Department of Transportation

MEMORANDUM

DATE: March 18, 2019

SUBJECT: ZC Case No. 17-21 – 501 I Street SW (The Bard)

Figure 1 – Site Plan (Source: CTR, Gorove/Slade, Figure 5, 12/3/18)

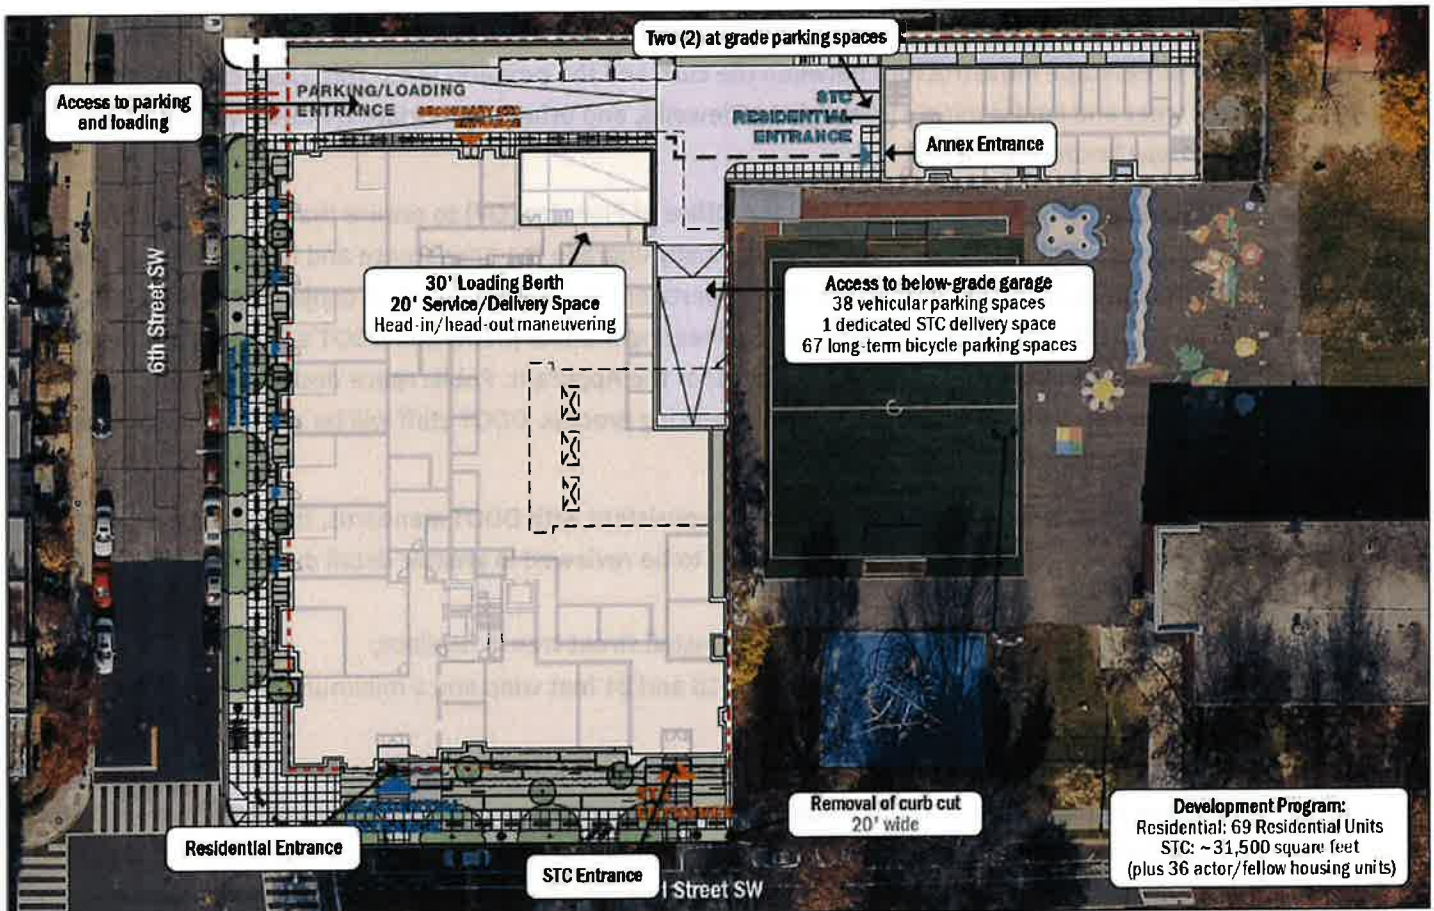
The proposed underground parking garage and above ground loading bays will both be accessed from a single curb cut on 6th Street SW in the northwest corner of the site. The existing curb cut to I Street SW in the southeast corner of the site will be closed. The building is proposed to have two (2) entrances on I Street SW, one for the residential component and one for the Shakespeare Theatre offices. Entrances to individual first-floor units will be provided on 6th Street SW. Figure 1 below shows the proposed site layout.

It is DDOT's understanding of Subtitle C § 901.1 of the 2016 Zoning Regulations (ZR16) that two (2) 30-foot loading berths and two (2) 20-foot delivery space are required for the site (one of each for each of the residential and Shakespeare Theatre components). The Applicant is only proposing to provide a total of one (1) loading berth and one (1) delivery space. Based on the Applicant's anticipated delivery schedule and move-in/move-outs, DDOT concurs that the proposed loading scheme can adequately serve the demand for loading facilities. Additionally, the Applicant has adequately demonstrated that all trucks can access the site from 6th Street SW with head-in and head-out maneuvers, consistent with DDOT policy. ZR16 also requires the loading berth be accompanied by a platform. It is unclear from the planset if this is being provided, therefore the Applicant should revised the planset to show a platform.

- Close the existing curb cut on I Street SW and install street tree in its place;
- Curb cut on 6th Street SW should be between 18 and 24 feet wide and a minimum of 6 feet from the northern property line;
- All vaults should be moved out of public space and onto private property;
- All building entrances adjacent to a public sidewalk should be at-grade with the sidewalk so there is no need for stairs or ramps in public space. There should be no swinging doors into public space;
- Ensure the building projections on 6th Street SW meet DDOT standards;
- Determine final locations and design for artwork to be installed along I Street SW;
- Determine final locations for the short-term bicycle spaces which should be in easily accessible locations, near building entrances, and preferably within the 'furniture zone' near the curb;

- Update the planset to show the inclusion of a loading platform attached to the loading berth;
- Update the Pick-up/Drop-off Operations Plan in the December 3, 2018 CTR to reflect the latest changes to proposed curbside uses on I Street SW, subject to DDOT approval;
- Implement the Loading Management Plan (LMP) and Parking Management Plan, as proposed in the December 3, 2018 CTR, for the life of the project, unless otherwise noted; and
- Implement the Transportation Demand Management (TDM) Plan, as proposed in the December 4, 2018 CTR, for the life of the project, unless otherwise noted, with revisions requested by DDOT (see end of this report).
